**Site Development at Brownsbarn Drive,  
Citywest Business Campus, Dublin 24  
Stage 1 Road Safety Audit**

## Stage 1 Road Safety Audit

Drawing No.	Drawing Title	Revision
D1678-D2	SITE PLAN WITH SWEPT PATHS	PL1

Figure 2.2 – HGV Conflicts at Access to Unit 1 and Unit 2

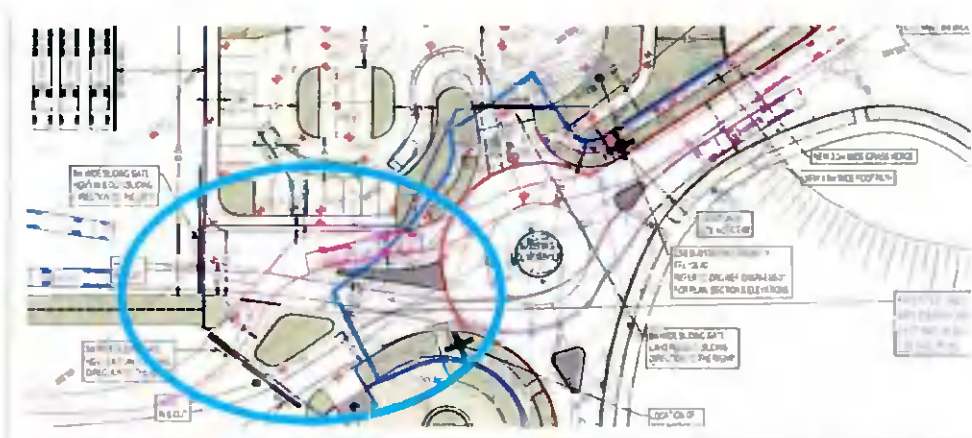
The HGV access arrangement for Unit 1 & Units 2 are in close proximity and could lead to conflicts between HGV's accessing the units which may result in collisions between HGV's and delays on the adjacent roundabout.

The access points should be separated and moved further away from the roundabout.

2.2	Yes	Yes	See also comments in response to item 2.1 with proposed removal of the compact roundabout.	Noted with thanks.
2.3	Yes	Yes	See also comments in response to item 2.1 with proposed removal of the compact roundabout, and note we have revised priorities within the access to Unit 1 car parking areas.	Noted with thanks.

Figure 2.3 – Car Park Access onto Roundabout

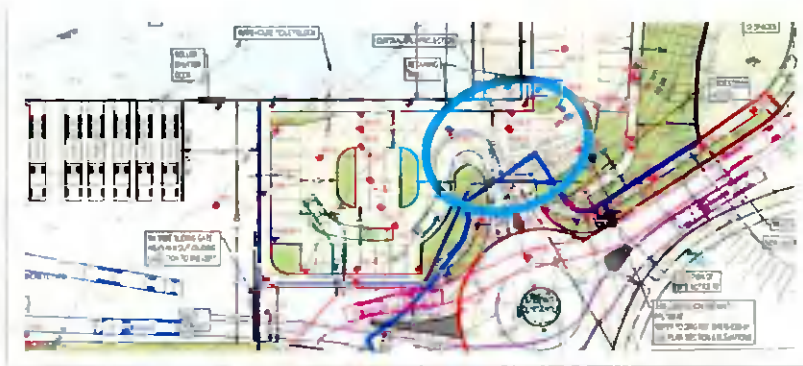
The constrained nature of this car park may result in collisions between vehicles navigating the entrance to the car park and lead to delays or secondary collisions on the roundabout.

The car park access should be closed and relocated away from the roundabout circulatory area.
